Staff Report & Recommendation

Design Review Board

SUBJECT: DRB19-0397
5245 North Bay Road

DRB19-0397, 5245 North Bay Road. An application has been filed requesting Design Review Approval for the construction of a new two-story single-family residence including one or more waivers and variances to reduce both required side yard and sum of the side yard setbacks and to exceed the maximum elevation for allowable encroachments in required yards, to replace an existing one-story residence.

Portion of the 1926 Plat of LaGorce Golf Subdivision (subject property Lot 2 Block 17)

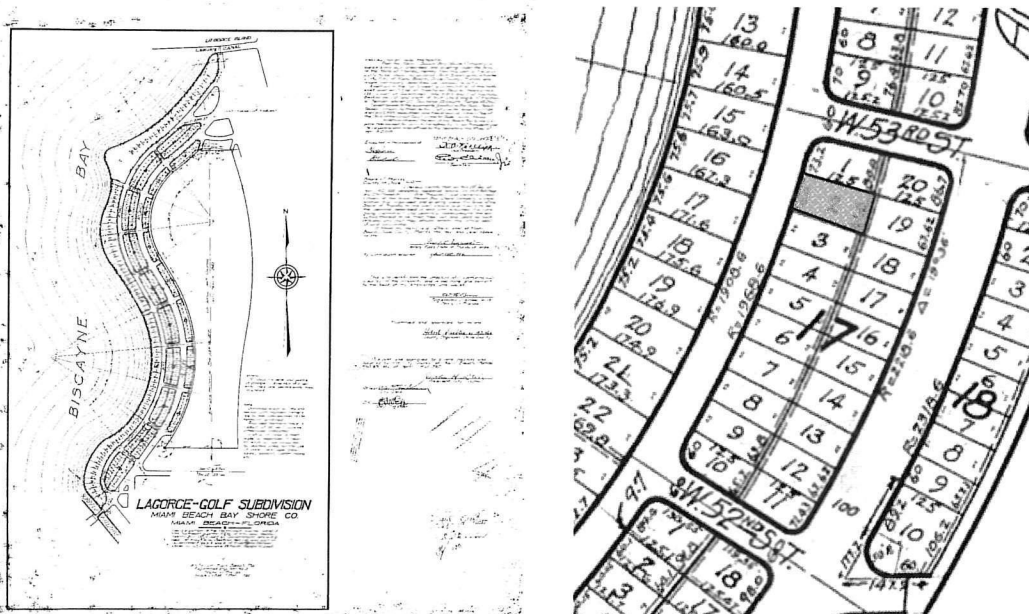
The property is an irregular shaped lot with a curved front property line of 60'-0" and a curved rear property line measuring 63.8'. Based on the parcel's geometry, is considered as 'a lot greater than 60'-0" in width' because the lot width is measured at the required 20'-0" front setback, which in this case results in a lot width larger than 60'-0". Therefore, both interior side yards have a minimum setback requirement of 10'-0". The applicant is proposing setbacks of 7'-6" on both side yards, as if the property were a rectangular lot with

60'-0" in width. Staff would note that the surrounding interior properties along the east side of North Bay Road and the abutting properties fronting Alton Road also have similar trapezoid shape with approximately 60' at the front and slightly wider toward the rear and located in the RS-4 zoning district. The properties on the opposite side of North Bay Road are subject to the same regulations of 10'-0" minimum side setbacks, yet those are larger; waterfront sites zoned RS-2.

The subject property is an interior lot on a block within the Plat of LaGorce Golf Subdivision, which was historically platted on April 9, 1926 as a series of eighteen serpentine interior blocks and a stretch of Bayfront parcels west of the La Gorce Golf Club and extending from Surprise Waterway to La Gorce Canal.
